**PAT-1 Safety Analysis Report Addendum  
Author Responses to  
Request for Additional Information**

**Docket No. 71-0361**

**Reference: Letter Eric Brenner, U.S. NRC to Maximo Barela, U.S.  
DOE-NNSA, dated March 1, 2010**

The NRC responded to the application for revision with a Request for Additional Information (RAI). This document addresses each of the NRC's RAI questions. A companion document, SAND2010-6109 provides the proposed changes to SAR Addendum.

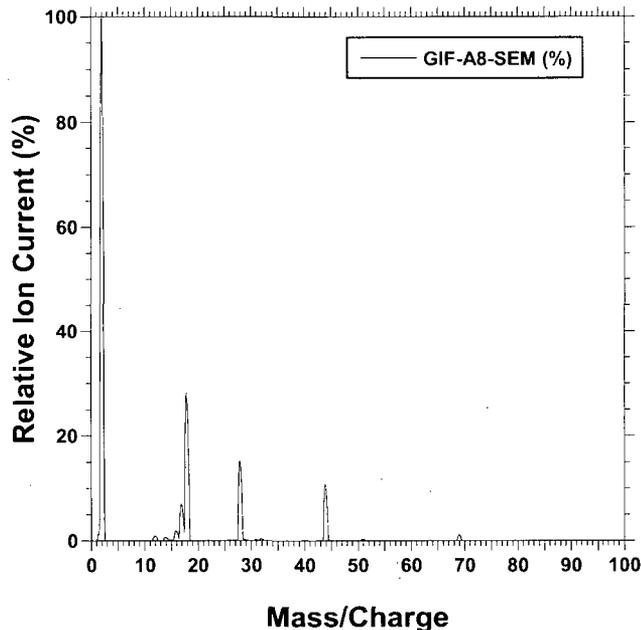
Place restrictions on the operating time of the package to prevent radiation damage to the elastomer seals in the package, and/or change the elastomeric seal materials. Clarify the radiation dose received by the elastomer seal on the TB-1.

The ORNL predicted doses for gamma ( $2.8 \times 10^4$  rad/year) and neutron ( $3.4 \times 10^4$  rem/year) radiation based on a realistic source are less than the  $10^5$  rad cited for no effect in the DuPont technical bulletin and are only marginally above  $10^4$  rad (cited in Bouquet, 3<sup>rd</sup> edition, 1990, (Ref. 1), treating neutrons and gammas equally and exposing for a full year. Note that the 3<sup>rd</sup> edition Bouquet reference only cites "fluorocarbons" and does not provide further details regarding manufacturers' data. In a 1985 article by Bouquet (Ref. 3), he shows in *Figure 4 Summary of Radiation Data for Elastomers. Property: Tensile Strength. Above Average Response Level* that the lowest threshold damage for Viton A® starts at about  $6 \times 10^6$  rads and the 25% change dose is at about  $6 \times 10^7$  rads. In *Figure 6 Summary of Radiation Data for Elastomers. Property: Elongation.*

*Average Response Level for Viton A*, the lowest threshold dose starts at about  $10^7$  rads and the 25% change dose is slightly above  $10^7$  rads. Thus this conservative dose estimate of about  $5 \times 10^4$  rads from the ORNL analysis places the seals under the "little or no effect" dose range for Viton® seals with a full year of contact according to DuPont (also conservative since most shipments should be completed within a month) and at least an order of magnitude below the threshold damage level data for tensile strength and elongation from the Bouquet 1985 article. Furthermore, the amount of time the seals would be typically in close proximity to the contents would make these estimates even closer to a  $1 \times 10^4$  rad cumulative dose for one year.

In conclusion, there is no need to place restrictions for the one year operating time of the package to prevent radiation damage to the elastomer seals because the Viton® A elastomer seals would experience no loss or minor loss in mechanical properties from radiation from the plutonium metal during NCT. Furthermore, the Viton® A elastomer seals in the T-Ampoule and SC-1 and SC-2 sample containers are not containment boundary components and do not provide a safety function but serve to maintain product quality.

Request for Additional Information: 2-8

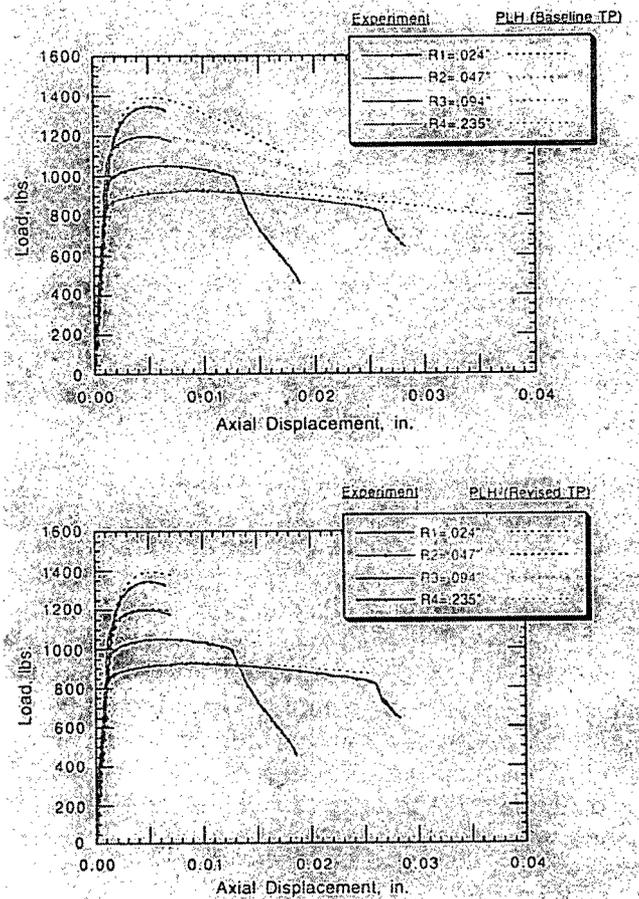
Describe in detail how the critical tearing parameter is determined and its relationship to the locus in equivalent plastic strain – stress triaxiality space.

The applicant derived the critical tearing parameter based on a finite element simulation of a uniaxial tension test. Given the multiple references to stress triaxiality, staff is unclear whether the formulation and use of a 1D acceptance criterion in conjunction with a 3D stress strain state locus is a consistent and relevant methodology.

First, this isn't a 1D acceptance criterion at all; it has been proven to work exceedingly well for many 3D stress states (in fact the addition of the 4<sup>th</sup> power over Brozzo's similar original failure criterion in 1975 was to better match highly notched, highly 3D specimens. See the figure below, where the upper graph compares notched tensile tests with FEA using the Brozzo failure criterion, and the lower graph shows a much better match using the updated Tearing Parameter (TP) [reference: Dawson, D. B., Antoun, B. R., and Mosher, D. A., "Fracture of Weapons Materials," Memo report to distribution, page 18, October 5, 1998, Sandia National Laboratories]). Even the uniaxial tension test used to determine the critical TP value is actually a 3D stress state (or at least 2D axisymmetric) due to the necking that occurs up to failure.

The TP equation needs to be slightly modified in SAR; (see below). The TP almost appears to have stress triaxiality within its definition because it (the integral) only accumulates value when the ratio inside the Heaviside brackets (tends to mimic stress triaxiality) is positive, but it also accumulates value (damage) much more quickly when the Heaviside ratio (mimicking stress triaxiality) is highly positive, as in near-perfect hydrostatic tension. But stress triaxiality is the mean stress (average of 3 principal stresses) divided by the von Mises stress, whereas TP has the difference of the maximum principal stress and the mean stress in the denominator.

Request for Additional Information: 2-9

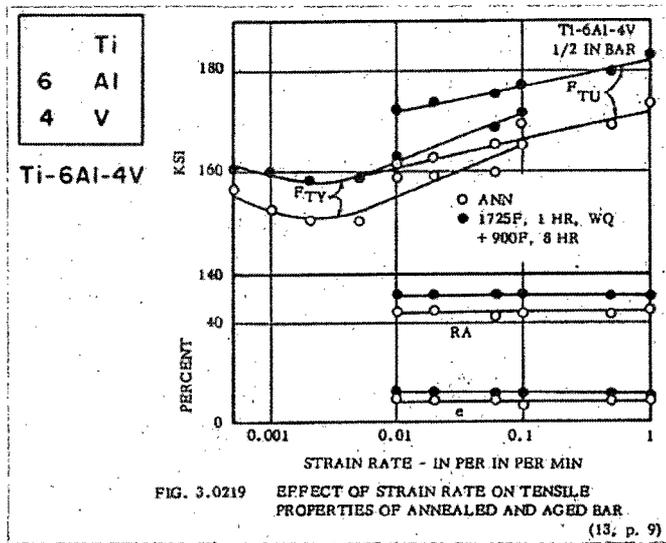
Demonstrate that the locus in equivalent plastic strain – stress triaxiality space is not strain rate dependent.

Given that this locus was developed at speeds of 200 ft/s rather than 422 ft/s, the applicant should provide a velocity range for which the locus is applicable. Alternatively, the applicant should provide a thorough explanation as to why the locus developed at lower velocity is acceptable to use outside of the regulatory framework requiring a velocity of 422 ft/s.

Some materials have high strain rate dependencies, but Ti-6Al-4V was chosen for the T-Ampoule eutectic barrier material due not only to its high strength, light weight, good ductility, and excellent corrosion resistance, but also because of its low strain rate sensitivity. For example, the material is commonly used in the aerospace industry for jet engine fan blades, in part because of its resistance to failure during bird strikes. At lower strain rates (0 to 1 inverse seconds), the yield and ultimate stresses harden slightly, but ductility is unaffected (reference graph from: "Department of Defense Aerospace Structural Metals Handbook", code 3707, page 12, March 1965), as shown below.
